**RE: ALTERATIONS AND ADDITIONS – S4.55 WORKS
2 TOURMALINE STREET, NARRABEEN**

Site Instruction

To	Micris Design, Bespoke Projects NSW		
Attention	Michael Di Ramio, Hassan Darwiche		
From	Sonia Cunningham, Tadd Walford		
Date	22 nd September 2020	Pages (Inc Header)	Page 1 of 5
Reference	2 Tourmaline Street, Narrabeen	Project No.	2019S0150
Subject	Assessment of existing walls and slabs and construction methodology adjacent to and beneath existing structure

Photo 4 – Spalling ground floor slab and exposed corroded reinforcement

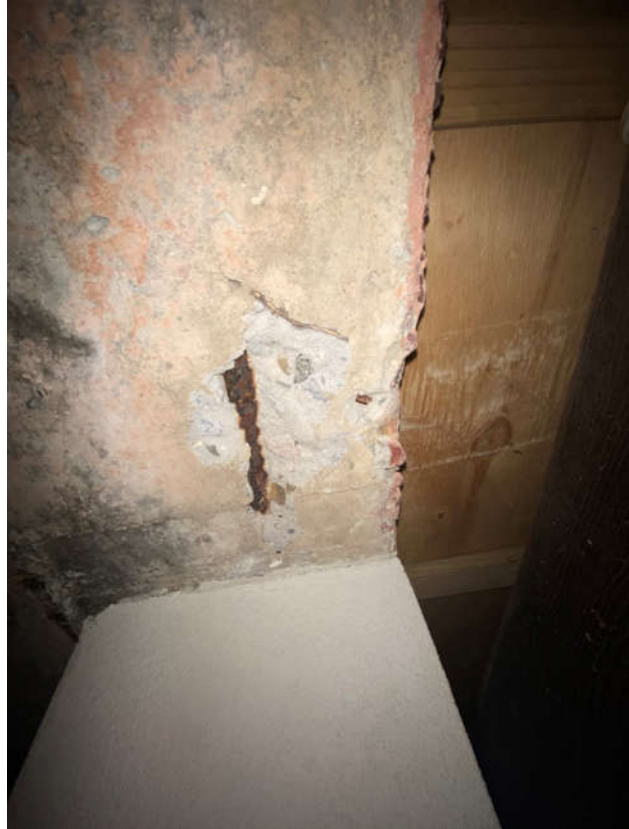
- Repair of the existing concrete slab would require the corroded reinforcement to be cut out and then repaired with new bars. Following this the spalled areas would be patched and repaired. However, we suspect the spalling observed indicates that the existing slab has insufficient concrete cover to the reinforcement, and so there is a high risk of further concrete spalling and corrosion of the reinforcement, especially considering the proximity to the ocean.

- Cutting the penetrations in the slab also exposes the reinforcement bars which creates a risk of further corrosion if not appropriately treated.
- We believe that the existing slab would require extensive repairs in order for us to certify its structural adequacy for the proposed works, and that it would be more prudent and efficient to demolish and rebuild the slab with adequate concrete cover to the reinforcement for the coastal conditions.
